Project	IEEE 802.16 Broadband Wireless Access Working Group < <u>http://ieee802.org/16</u> >							
Title	HARQ refinements							
Date Submitted	2005-03-09							
Source(s)	Yigal Eliaspur, Ilia Bosis, Yuval Lomnitz, Sharon Ben-Porath, Noam Kagan Intel Corp.							
Re:	IEEE P802.16e/D6							
Abstract	.Refinements and corrections for HARQ in Normal MAP feature							
Purpose	Adoption of proposed changes into P802.16e /D6							
Notice	This document has been prepared to assist IEEE 802.16. It is offered as a basis for discussion and is not binding on the contributing individual(s) or organization(s). The material in this document is subject to change in form and content after further study. The contributor(s) reserve(s) the right to add, amend or withdraw material contained herein.							
Release	The contributor grants a free, irrevocable license to the IEEE to incorporate material contained in this contribution, and any modifications thereof, in the creation of an IEEE Standards publication; to copyright in the IEEE's name any IEEE Standards publication even though it may include portions of this contribution; and at the IEEE's sole discretion to permit others to reproduce in whole

Table 283 H-ARQ MAP or Sub-MAP Pointer IE Format

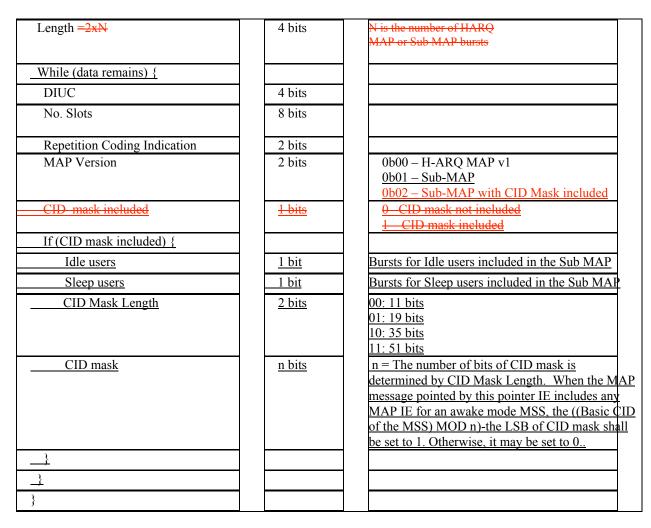
[change the following in table 283]

Syntax	Size	Note	
H-ARQ and Sub- MAP Pointer IE {			
Extended DIUC	4 bits	H-ARQ MAP Pointer = $0x07$
